DEVELOPMENT ASSESSMENT CASE NUMBER: CD-2022-0002 – 311-315 South Congress Planned Unit Development

COMMENT REPORT

CASE NUMBER: CD-2022-0002
CASE MANAGER: Wendy Rhoades

PROJECT NAME: 311 - 315 South Congress PUD

TREE LIST	
NUMBER	DESCRIPTION
5000	17" LIVE OAK
5001	8" LIVE OAK
5002	9" LIVE OAK
5003	15" LIVE OAK
5004	13" ASH
5005	33" ASH
5006	23" ASH

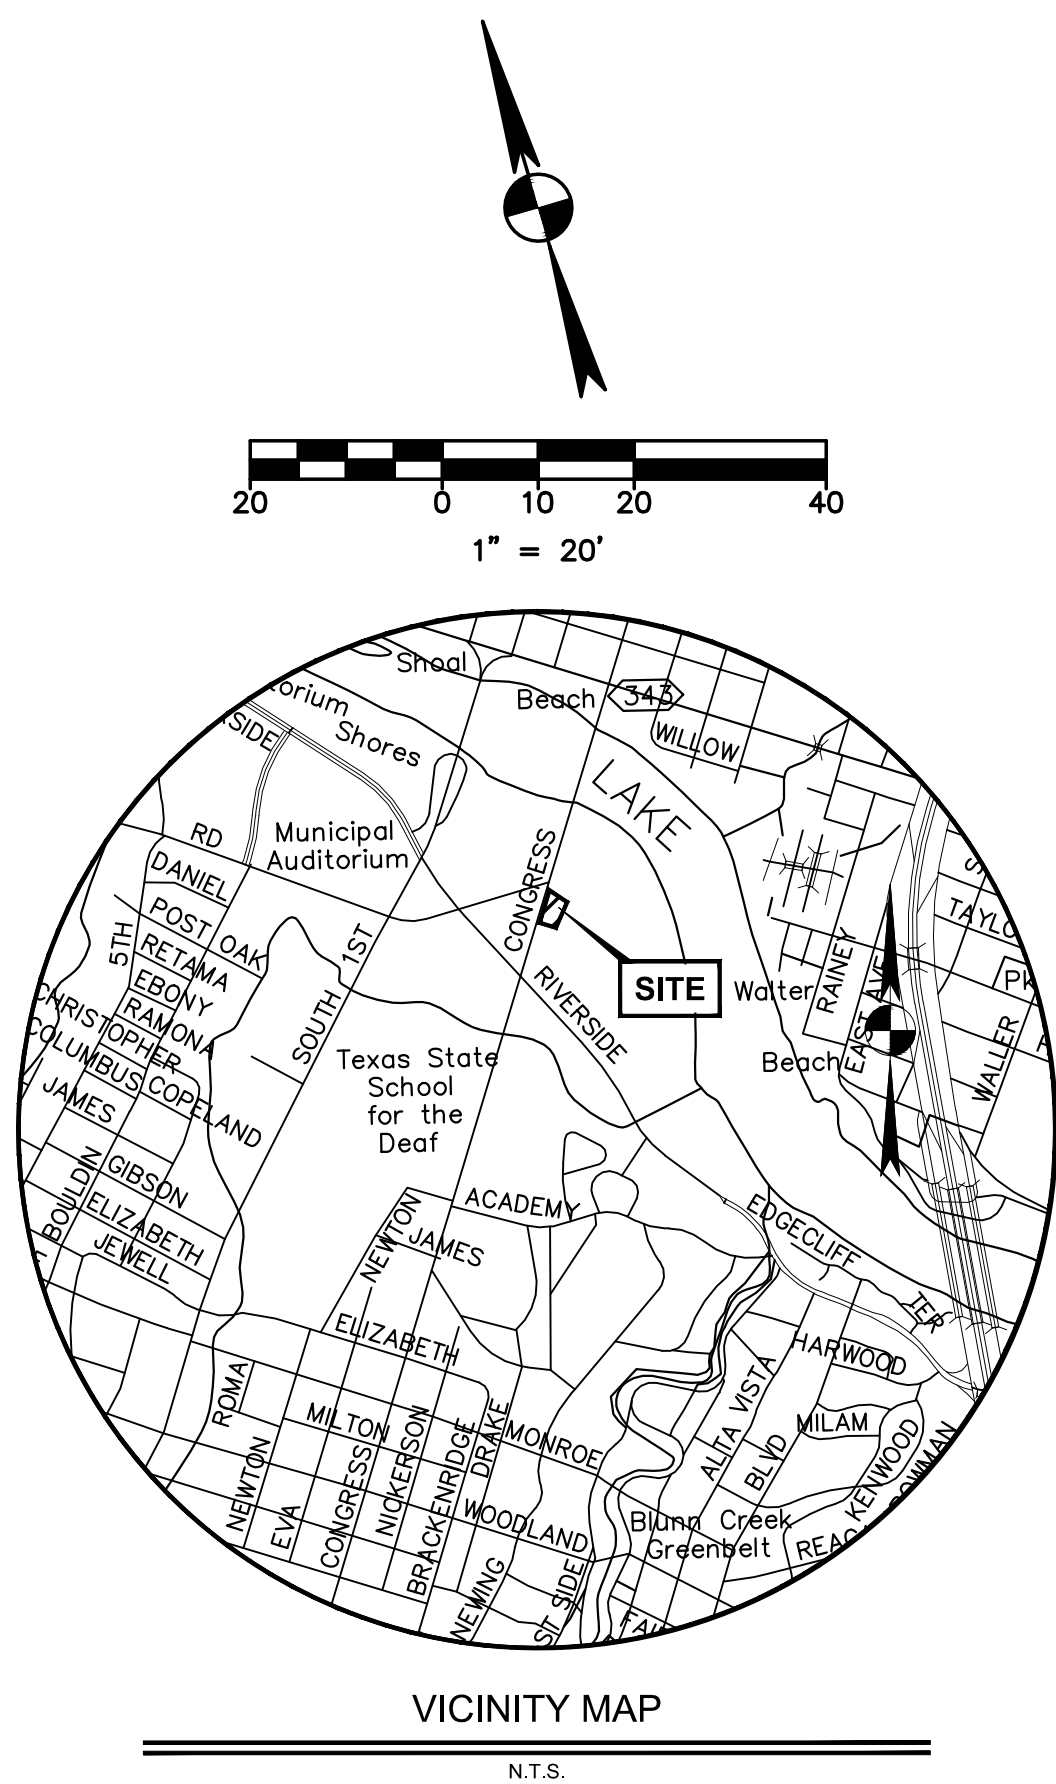
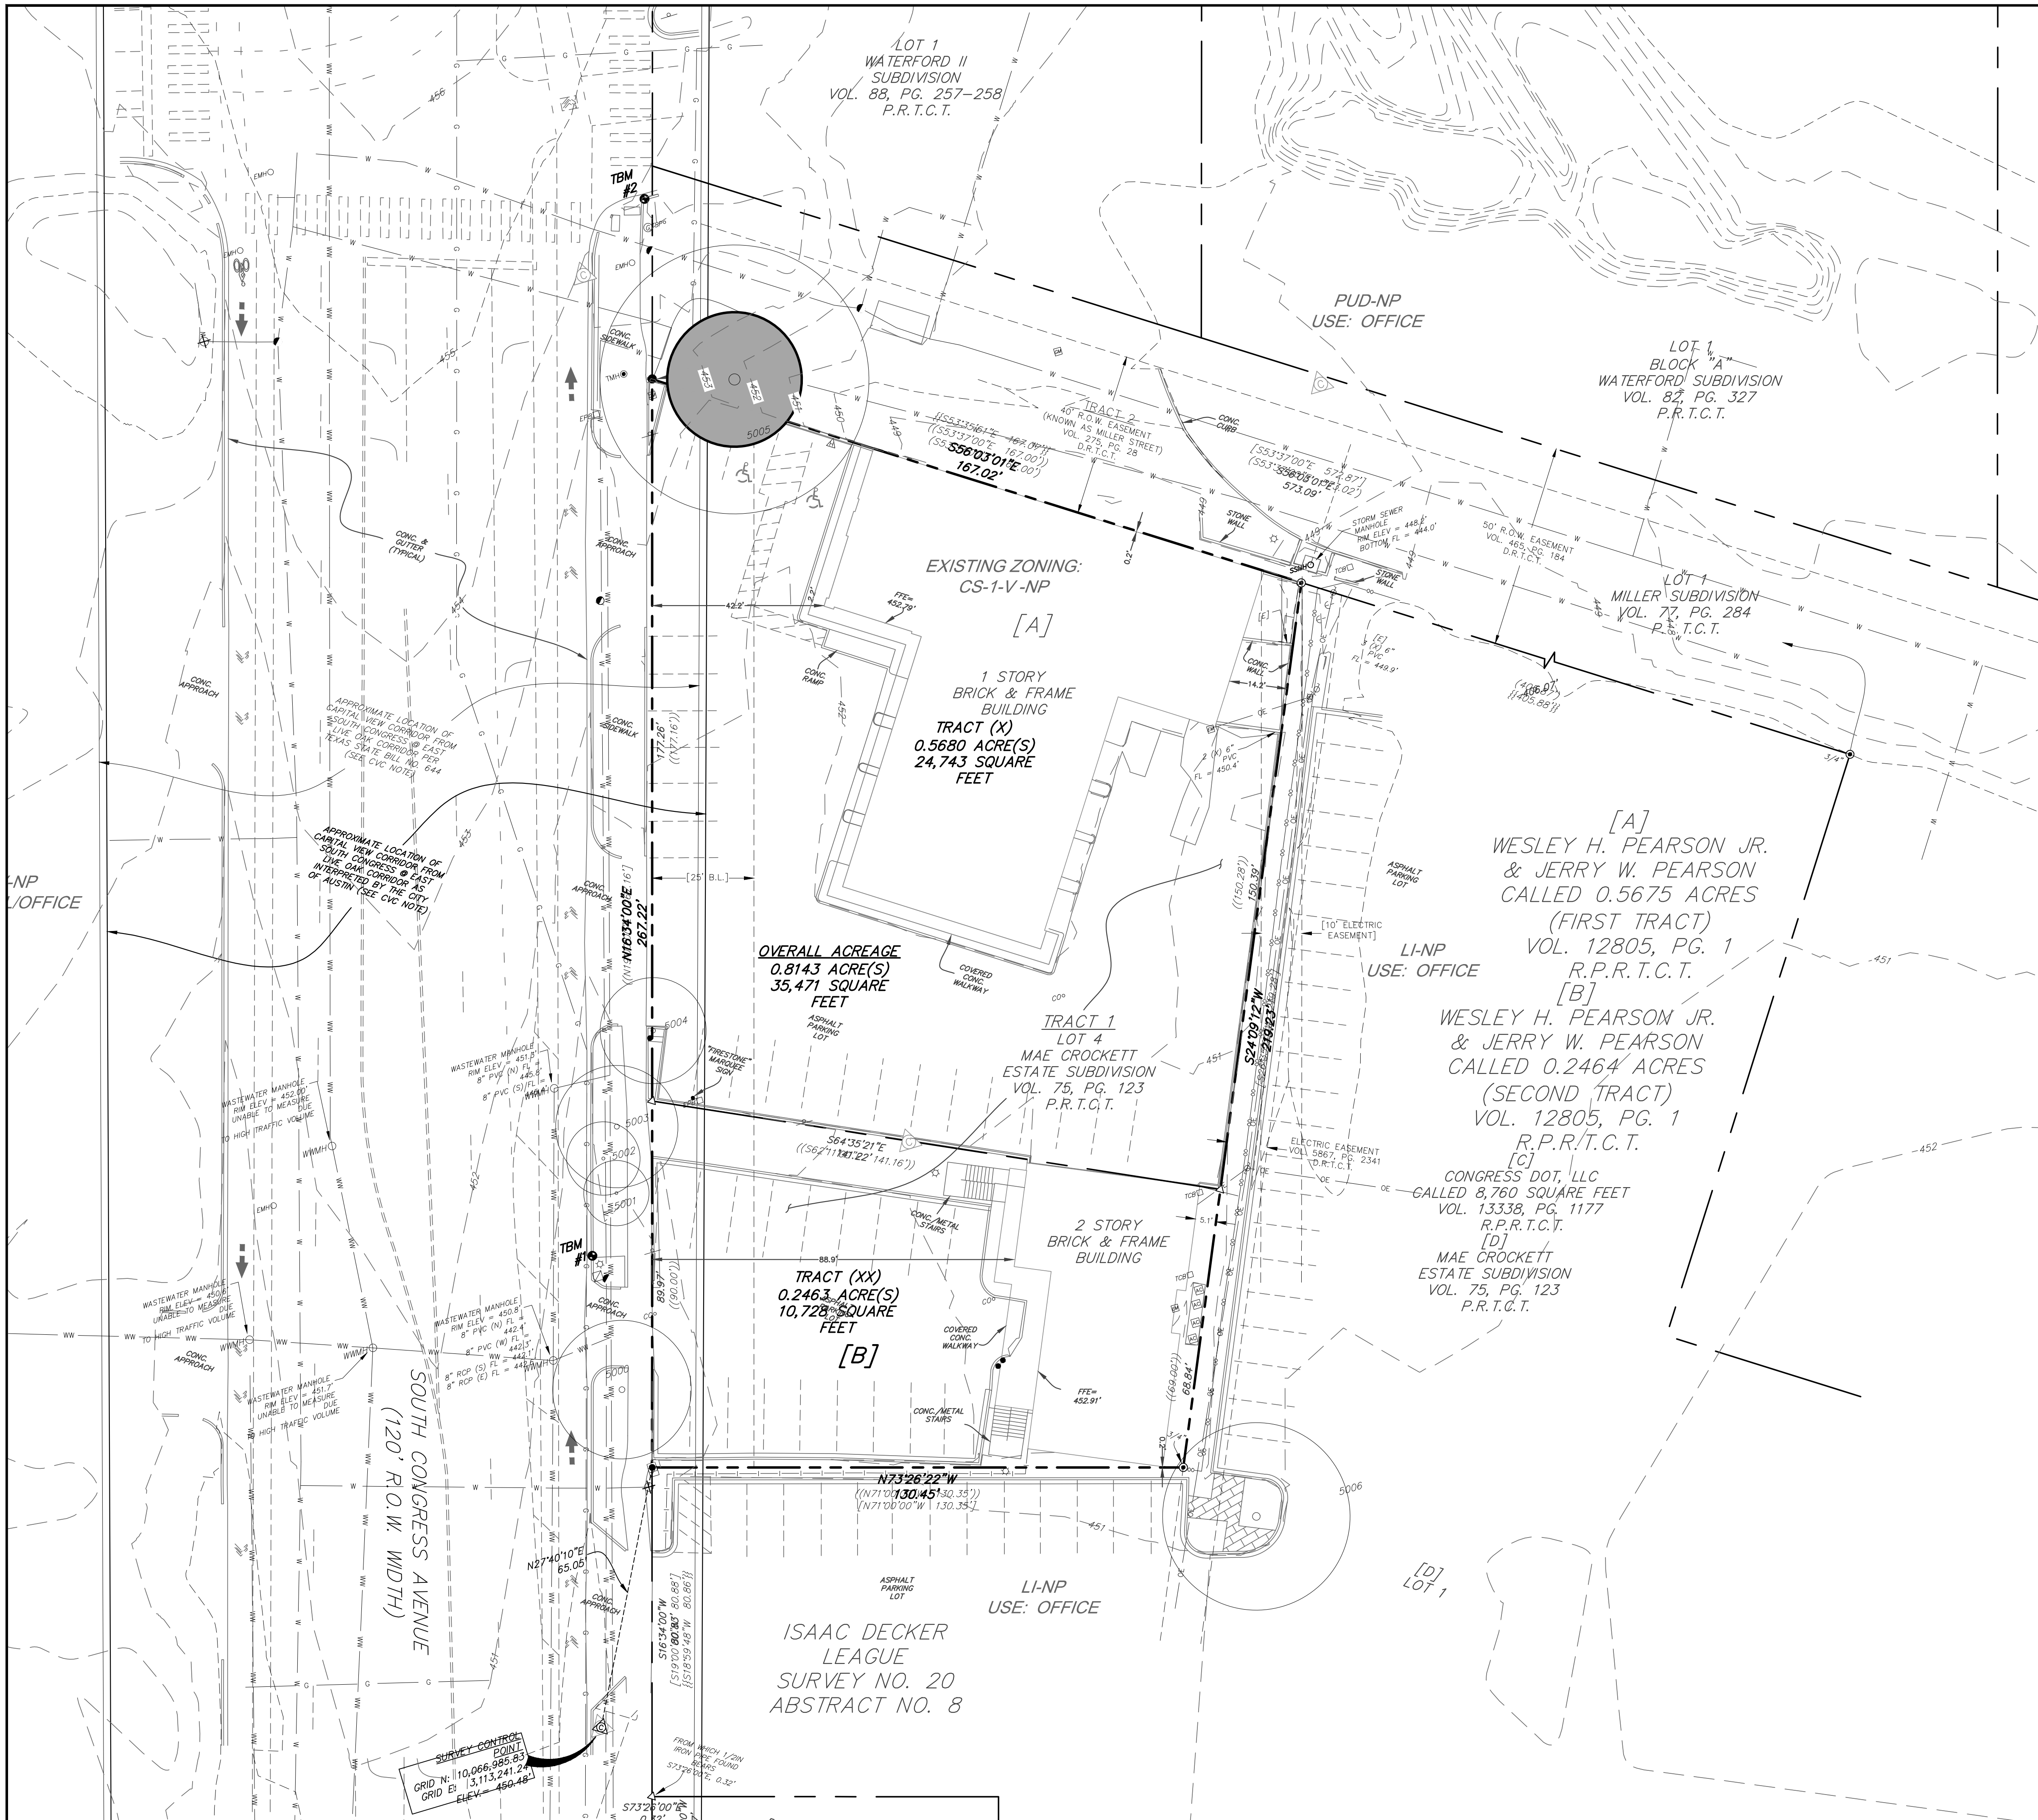
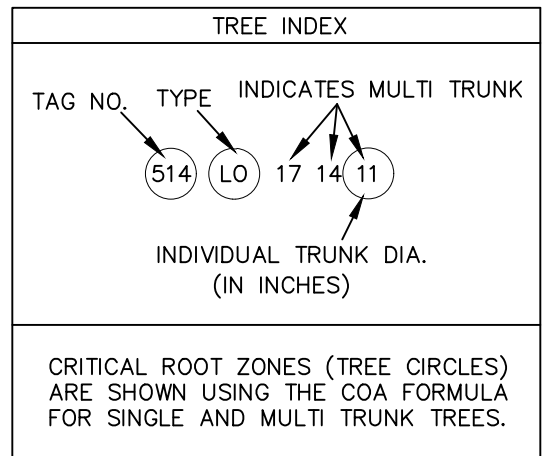
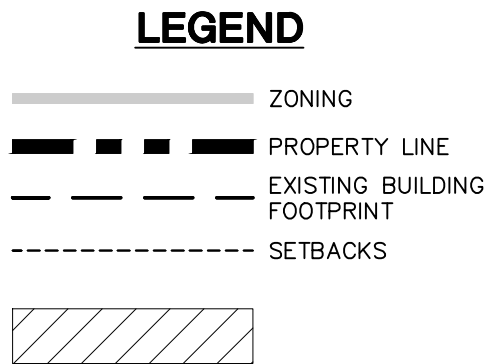
- CA 5 Please clarify the tree survey as Tree 5005, a 33” Arizona ash. The City has previously issued a dead diseased imminent hazard tree permit for its removal.
